**From:** Paul Brock <brock\_paul@hotmail.com>  
**Sent:** Wednesday, January 8, 2025 10:39 AM  
**To:** G.Proj.Wood at Viewcrest; Bell, Kathy M.; Sundin, Steven C.  
**Cc:** Lyon, Blake G.  
**Subject:** The Woods at Viewcrest, Applicant 4th RFI Response

**RE:** The Woods at Viewcrest — Applicant's response to fourth RFI

Re: The Woods at Viewcrest — Applicant's response to fourth RFI

## Attachment A

#### Legend Fecal Coliform Sample Results

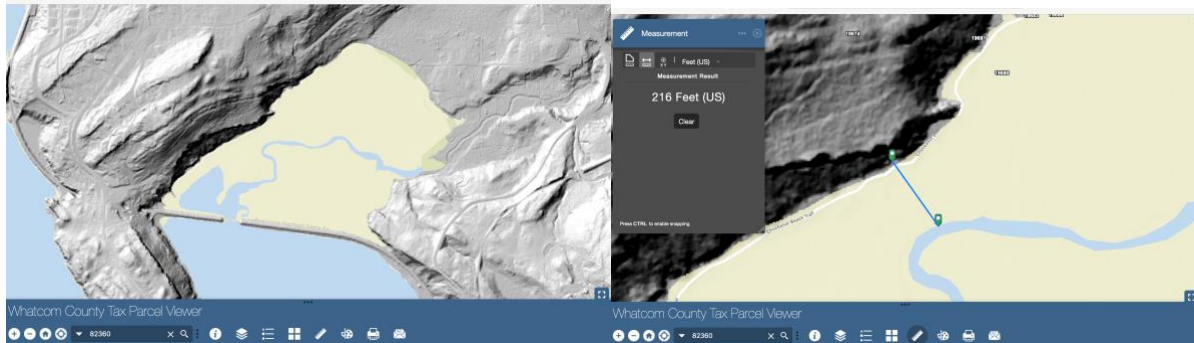
PMBC response: Applicant's project documents compare the proposed new stormwater outfall discharge to the existing outfall discharge at Arbutus Place. Years of sampling data taken at the stormwater discharge outflow pipe at Arbutus Place consistently reveal fecal coliform levels exceeding health standards. The data also consistently show that the high fecal coliform levels from this outfall discharge exceed samples taken from any other location within the boundaries of Mud Bay.

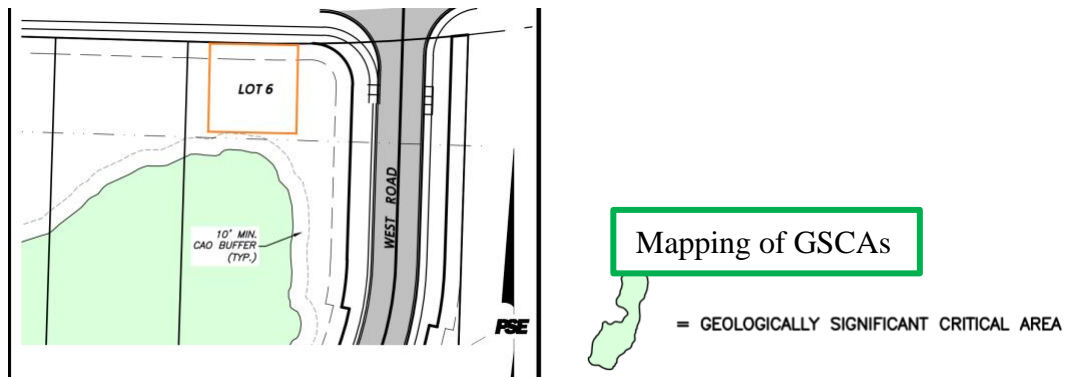
The Geotechnical Investigation and Geohazard Report did not include sufficient information to determine if the proposed building envelopes, shown on Figure 3B of said investigation and report, are outside of recommended buffer widths from landslide hazard areas for specific lots.

*City Action Item: "The Geotechnical Investigation and Geohazard Report did not include sufficient information to determine if the proposed building envelopes, shown on Figure 3B of said investigation and report, are outside of recommended buffer widths from landslide hazard areas for specific lots."*

**City:** **a)** "Submit a map identifying the preliminary plat map with building envelopes, site's landslide hazard areas and the recommended buffer widths".

**b)** "Our 4/28/2022 RFI requested showing adequate buffer widths for lots 25-35 but that has not been clearly provided."

Below is an example of the applicant's currently used project property maps depicting GSCAs, rather than the required Landslide Hazard Areas (LHA), LHA buffer areas, and Erosion Hazard Areas (EHA), and EHA buffers:

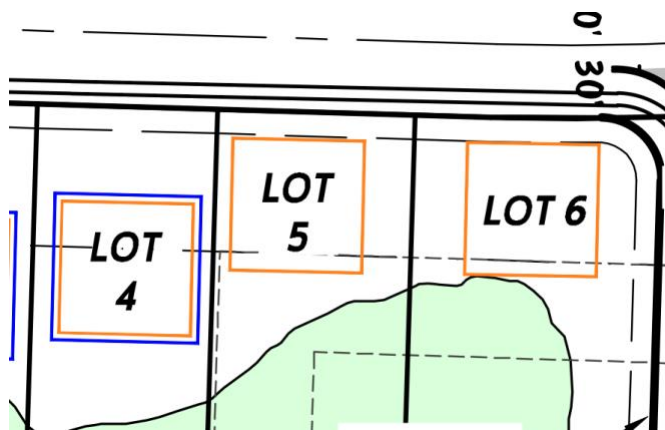
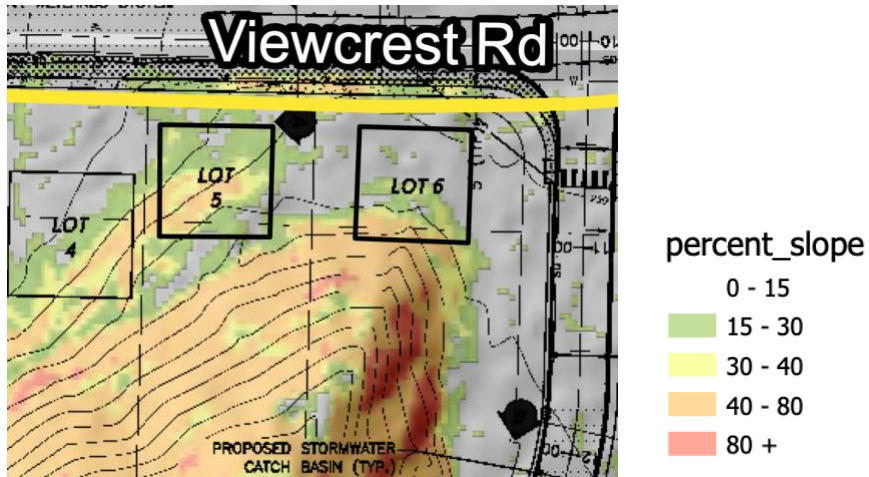
- A. Exhibit BB Sheet 1 of 9 depicts a green area as a “geologically significant critical area.” The Woods at Viewcrest project has created, and now uses, this invented “GSCA” on the applicant’s maps, instead of BMC-defined and required Landslide Hazard Areas (LHA), LHA buffers, Erosion Hazardous Areas (EHA), and EHA buffers. This invented-by-the-applicant ‘GSCA’ is NOT a legal substitute recognized in Bellingham’s BMC, and it is not a property terrain area defined or used in Bellingham’s BMCs. GSCAs cannot legally replace LHA, EHA, or LHA/EHA buffer areas on project maps for compliance. It is unacceptable and non-compliant of regulations to invent and substitute GSCAs as an equivalent area representing BMC-defined LHAs, LHA buffers LHAs and LHA buffers. A boolean search in the Bellingham Municipal Code for "geologically significant critical area" has no matches. BMC requires exacting measurements associated with this project’s numerous critical areas, and exacting distances reflecting the proposed development’s proximity and/or encroachment on critical areas: on this complex site, these this information is of utmost importance for a host of decisions the city must contemplate.

- **NO BMC landslide hazard area (LHA) or LHA buffer area is delineated**, instead a project-defined GSCA is drawn.

- **NO BMC erosion hazard area (EHA) or EHA buffer area is delineated**, instead a project-defined GSCA is drawn.

Most of the building envelope area proposed for Lot 5 is shown within a LHA and EHA. No buffers are shown. All of the building envelope for Lot 5 will be within landslide hazard area and its buffer area, and erosion hazard area and its buffer.

Most of the the building envelope proposed for Lot 4 and for Lot 6 will be within a landslide hazard area and its buffer area, and an erosion hazard area and its buffer.
